No: 25-100

Dauphin County Subdivision/Land Development Review Report

Municipality	City of Harrisburg	Surveyor	NA	Engineer	By Design Consultants (ARCHITECTS)
Plat Title	Renovations for Residential Conversions 333 Market Street				
Zoning District	CBN – Central Business District	Proposed Land Use	Residential

Project Description: Renovations of the top 9 floors of former office tower into one – two bedroom apartments

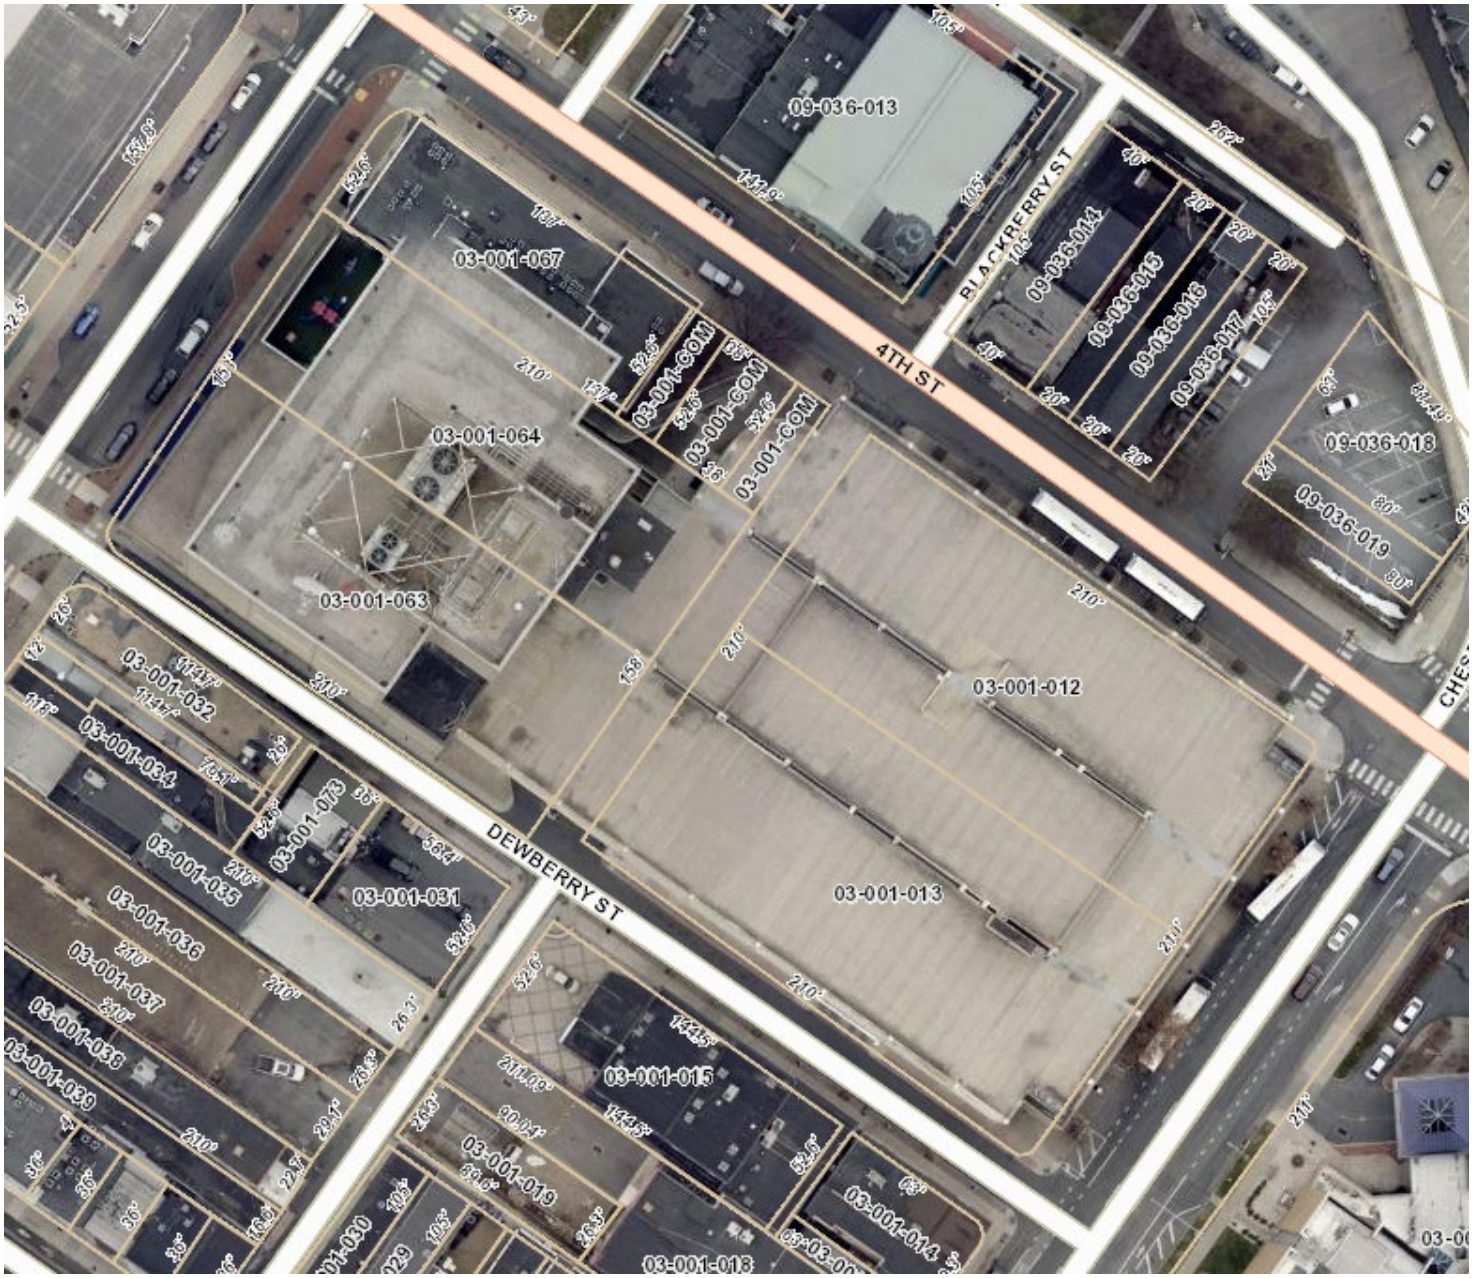
2. In addition, the property appears to be located on several lots and also included is a un opened street or right of way. (See attached screen shot from Dauphin County parcel view/ web page / data base) As the submitted plans does not have any of this information, it is recommended that the applicant work with the City to rectify this property overlap and / or anomaly in coordination with this modification. This may also be in consideration as at this time the plan is being reviewed as a land development. And also no property information for the plan is even presented – thereby making it difficult to review for compliance or compliance with the City's development provisions.
